Amendments to the Drawings

REMARKS

Fig 5

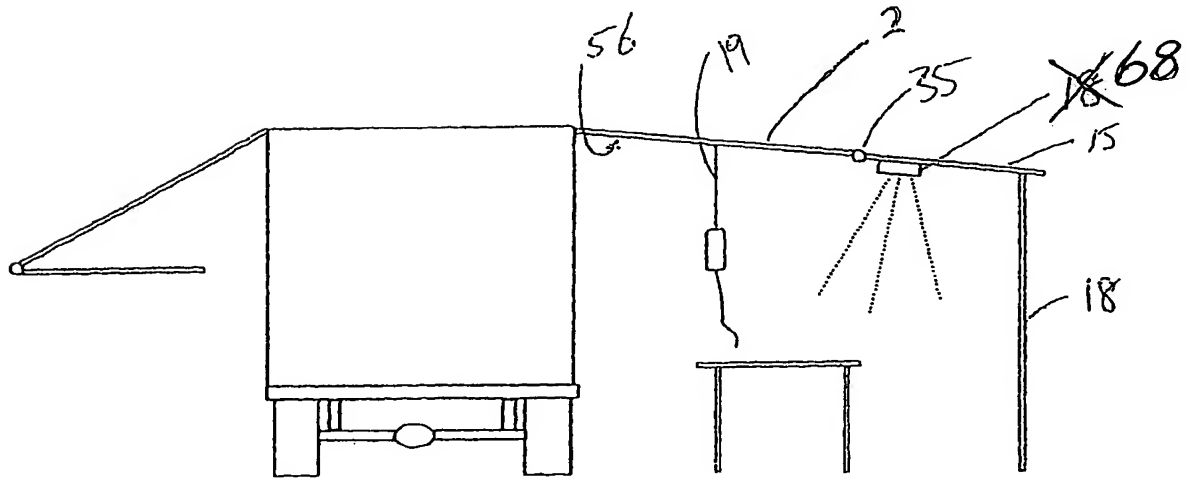
The drawings stand objected to as failing to comply with 37 CFR § 1.84(p)(4) due to the numeric identifier “18” being utilized to designate both the light source and the post in Fig. 5. A corrected drawing sheet is submitted herewith in accordance with 37 CFR § 1.121(d). In the corrected drawing sheet the numeric identifier for the light source has been corrected to “68” in correspondence with the text at page 6, paragraph 84.

Fig. 5 is amended to correct the numeric identifier for the light source to “68” in correspondence with the text at page 6, paragraph 84.
